GOMEZ DRIVEWAY & BACKYARD REMODEL

Dear Village of Pinecrest Plan Reviewers,

In response to your plan review comments, please see written responses below addressing each discipline. Each item has been addressed on the resubmitted plans, and clouded under **Revision 02**.

Public Works

OVERALL SITE PLAN
SCALE: 1/16" = 1'-0"

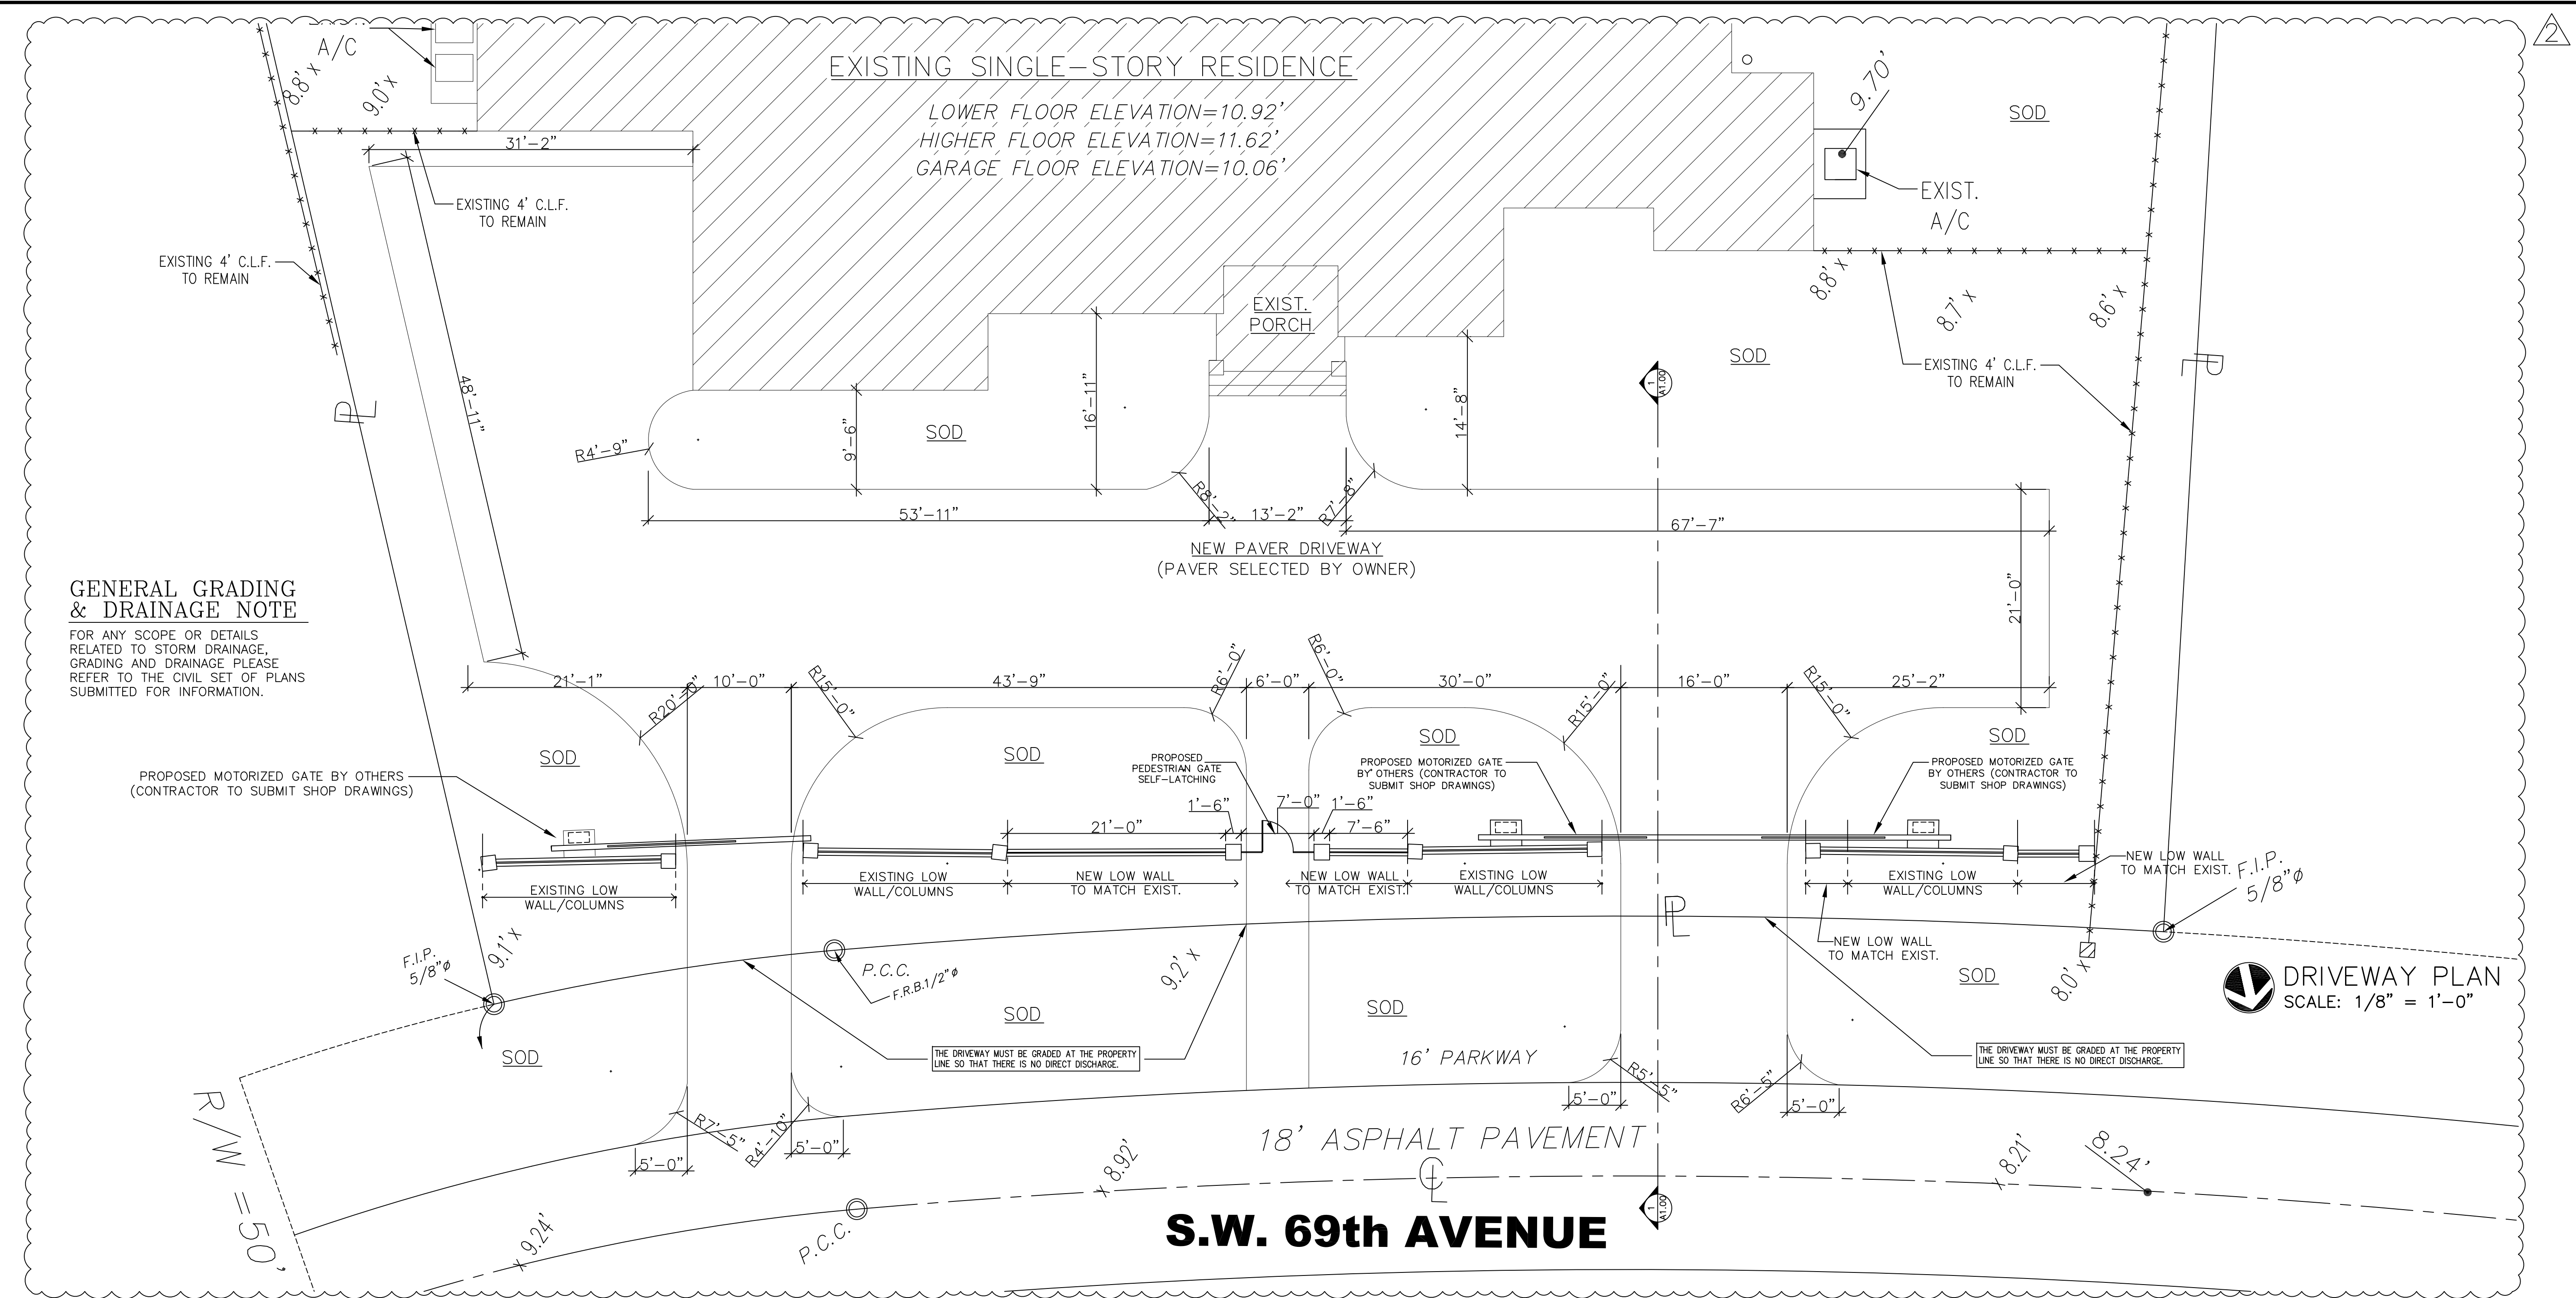
1. Sheet A1.00: No dimensions are provided for the proposed driveways nor walk way.
 - a) **RESPONSE:** Dimensions are not provided on A1.00 because that sheet is not intended for detailed information. The dimensions are provided on sheet A1.02. You can see there is a note on sheet A1.00 with dotted area that says to refer to sheet A1.02 for a blown up section of this area.
2. Sheet A1.00: Show the location of the fence/gate in the profile. The idea is to keep runoff from leaving (discharge from) the property directly.
 - a) **RESPONSE:** See revised profile detail on sheet A1.00, showing the location of the column and gate, relative to the sloping. Runoff will slope back into the property.
3. Review and implement the Conditions of Permit.
 - a) **RESPONSE:** See revised sheet A1.00 for listed PW conditions of permit.

4. Sheet A1.00: Swale detail provided is inadequate to accomplish the intent of the Village's Stormwater Management code.
a) **RESPONSE:** Please refer to new civil set of plans.
5. Any sheet: provide the proposed materials for the new driveway.
a) **RESPONSE:** Sheet A1.02 states that the driveway material is to be pavers.
